ADDENDUM # 2

BID # 7461317

BID TITLE: FURNISH AND INSTALL 2 GENERATORS
BRISTOL AND MIDDLETOWN ARMORYS

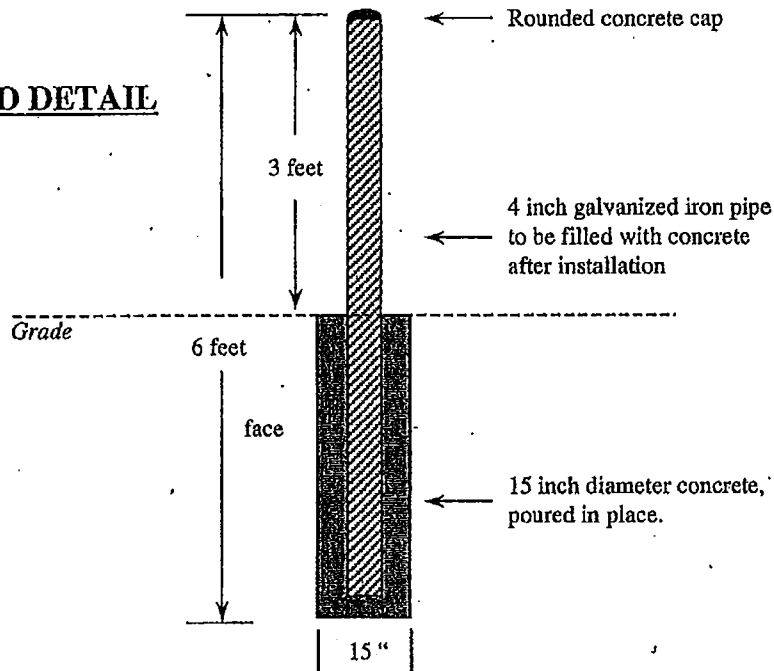
Q 4) It was stated at the Pre-Bid meeting that a remote annunciator is being requested to be installed at each location, at the front entrance of the buildings, adjacent to the fire alarm control panels. Please specify what functions/how many lamps are to be included within the annunciator.

A. GENERAC 5465 IS THE PRODUCT WE ARE LOOKING FOR.

Remote annunciators to be provided at fire alarms boxes in both locations.

BOLLARD DETAIL

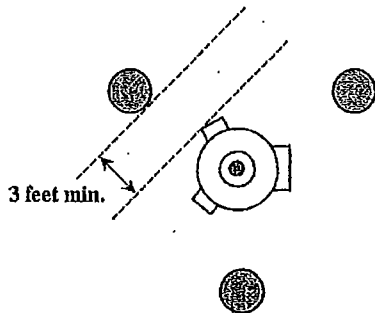
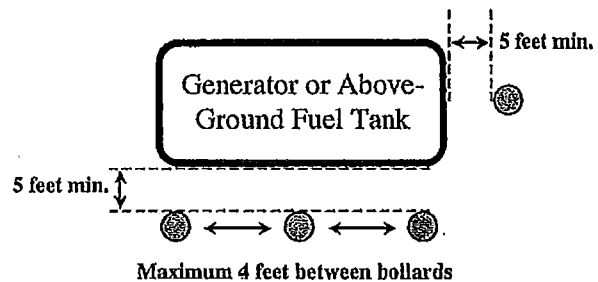
Q 3) To confirm, we are to install protective bollards at both locations. Total of (16), (8) at each. Please provide a specification on the bollards. Should they be galvanized? Should they be filled with concrete? How far in the ground should they go and how far above grade should they be? Should they be set in a sonitube below grade? Etc..

A. THE ATTACHMENT SHOULD ANSWER ALL QUESTIONS ON THE BOLLARDS.

Bollards shall be three (3) feet minimum from the face of fire hydrant. All orifices shall be unobstructed.

Bollards shall be five (5) feet minimum from the face of fire hydrant.

3000 PSI concrete will be used; bollards will be covered with safety yellow bollard sleeves. Due to location restraints on-site modification to specifications can be authorized by the construction supervisor
